<b>Alberta</b> TRANSPORTATION AND UTILITIES Traffic Operations Branch	DWG. No.	TEB 3.26
	Date	DEC. 13/92
	Revision	
	Revision

**MEDIAN BOX BEAM GUARDRAIL  
 INSTALLATION DETAIL FOR  
 END TREATMENT**

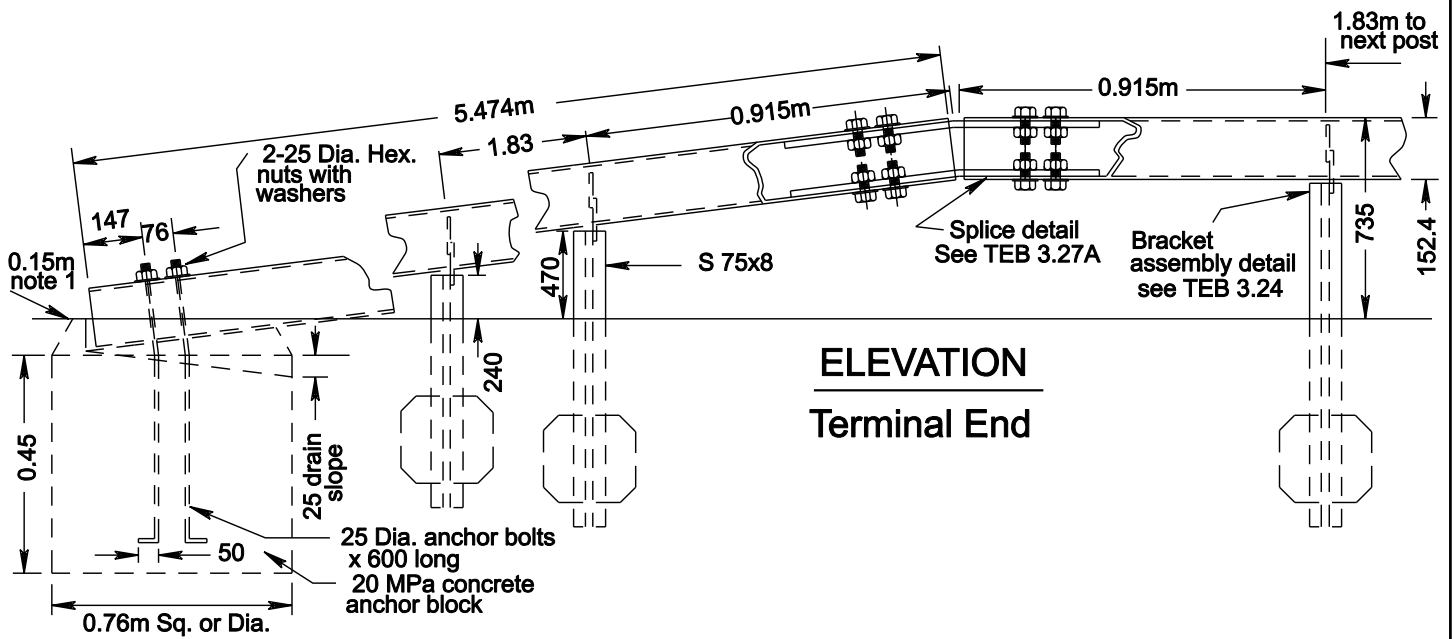
1 SEPT. 2011. TURN DOWN ENDS WILL NO LONGER BE ACCEPTABLE FOR NEW INSTALLATIONS OR REPLACEMENT OF EXISTING ENDS. CRASH WORTHY END TREATMENTS SHALL BE USED.

20 NOV. 2012. WHERE EXISTING TURN DOWN END TREATMENTS NEED TO BE RE-BUILT AND/OR REPLACED DUE TO BEING HIT BY AN ERRANT VEHICLE, THE REPLACEMENT WITH A CRASHWORTHY END TREATMENT IS SUBJECT TO FUNDING AVAILABILITY.
